Rev A - 091009

**Rev A**

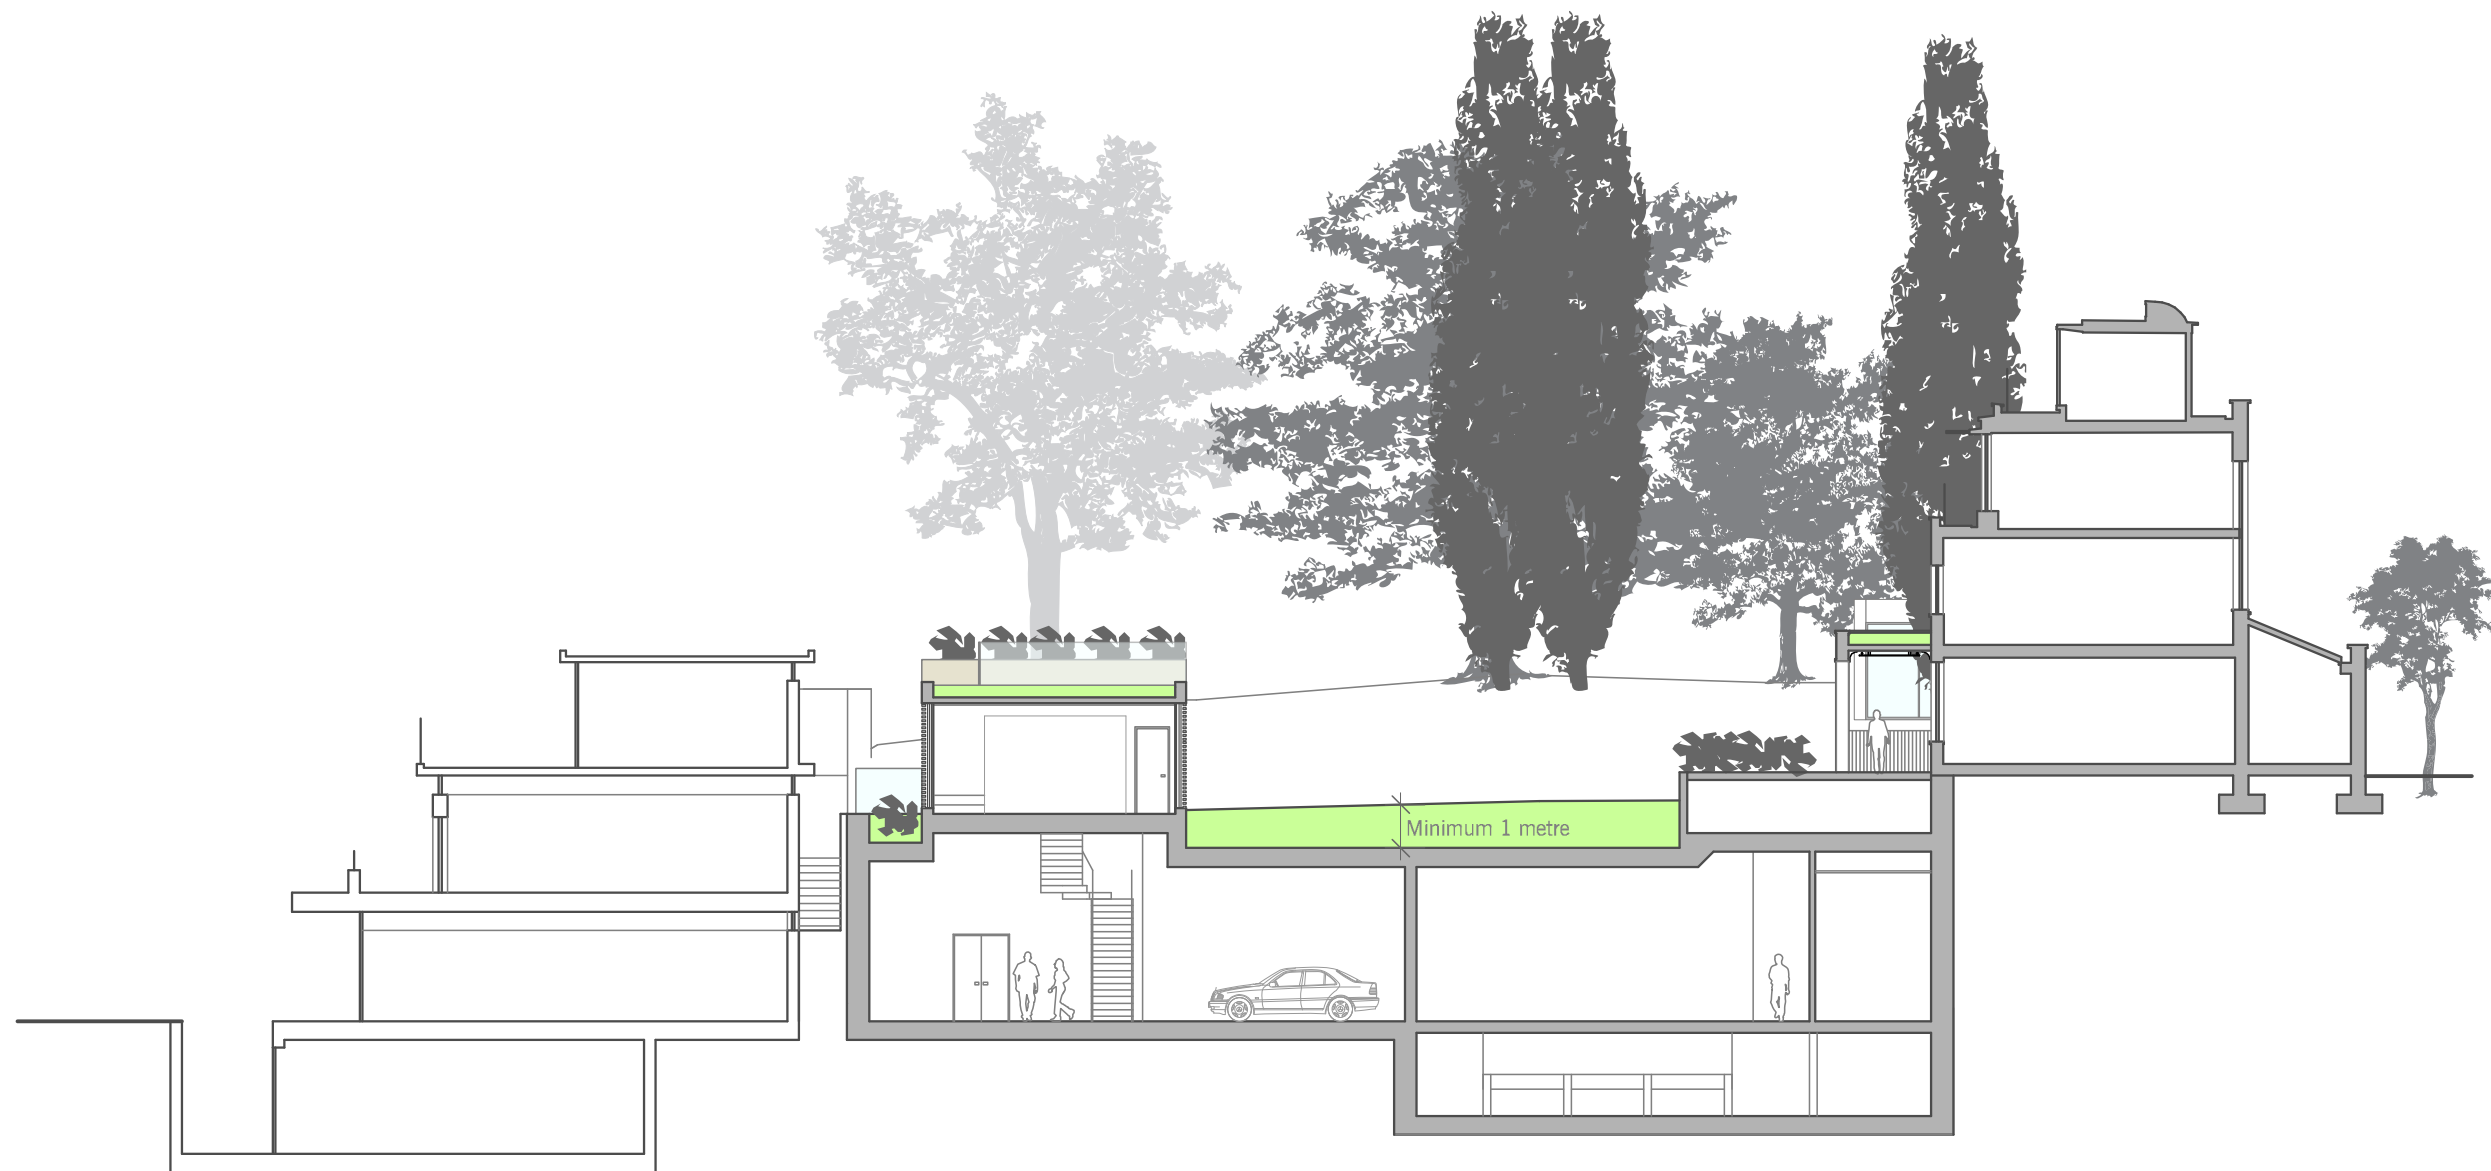
Centre landscape depth increased.

Centre landscape depth increased.

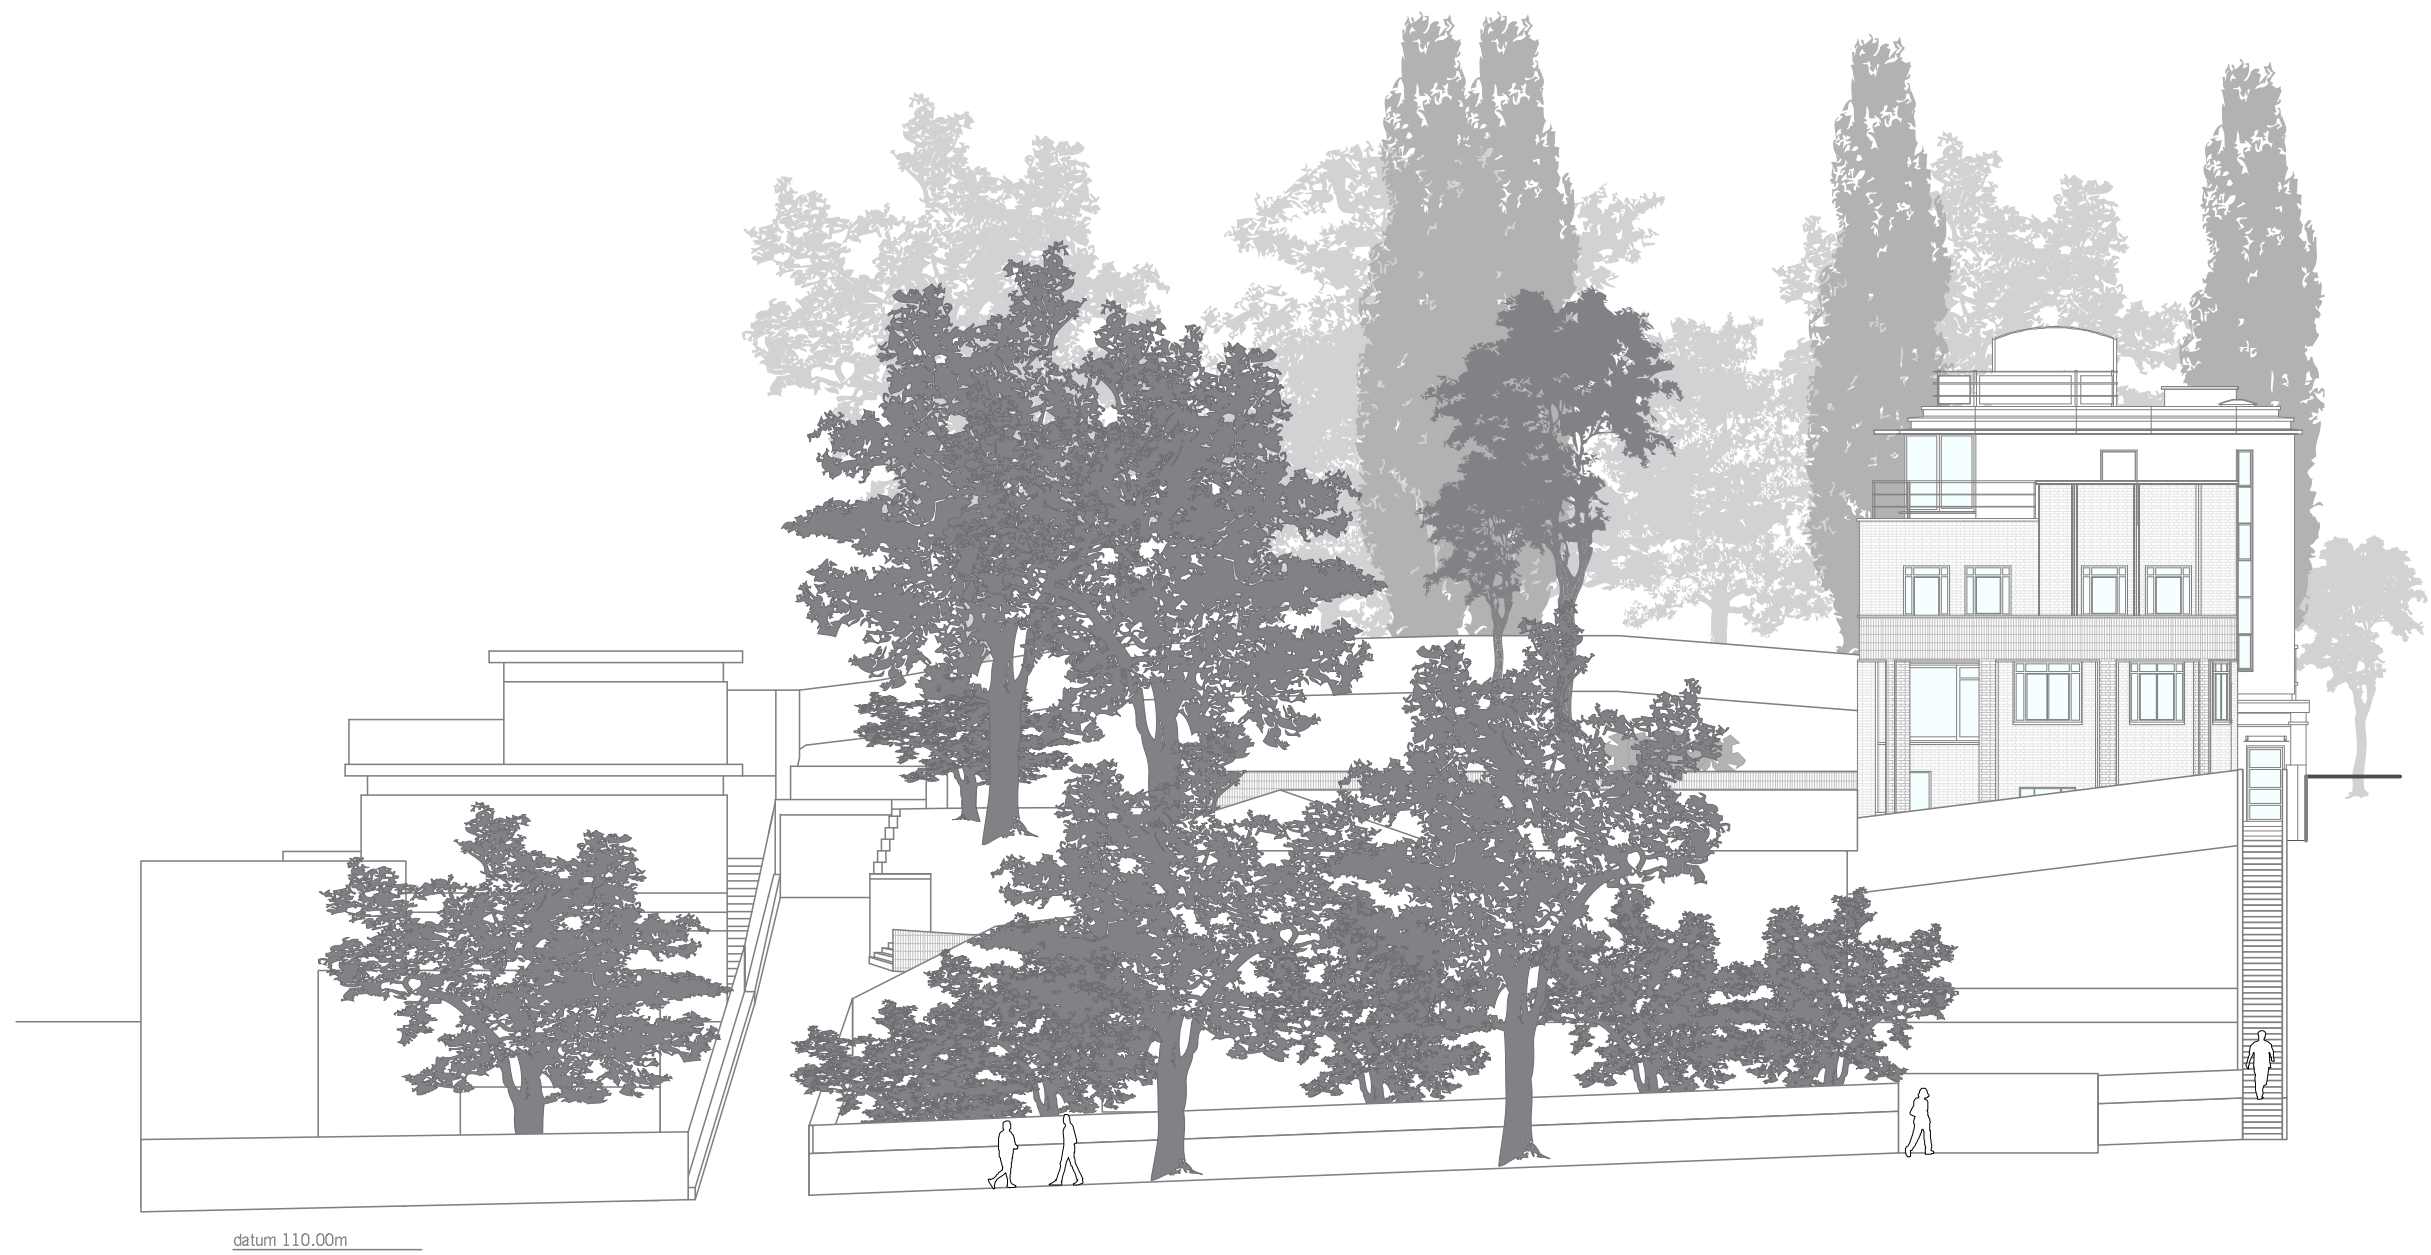
Non-accessible low level planter added to south of annex.

1.2m glazed screens added to prevent access and overlooking to no 85A.

1/3 of library window specified obscured glass and non-openable.

Planters and guarding added to roof of annex at rear.
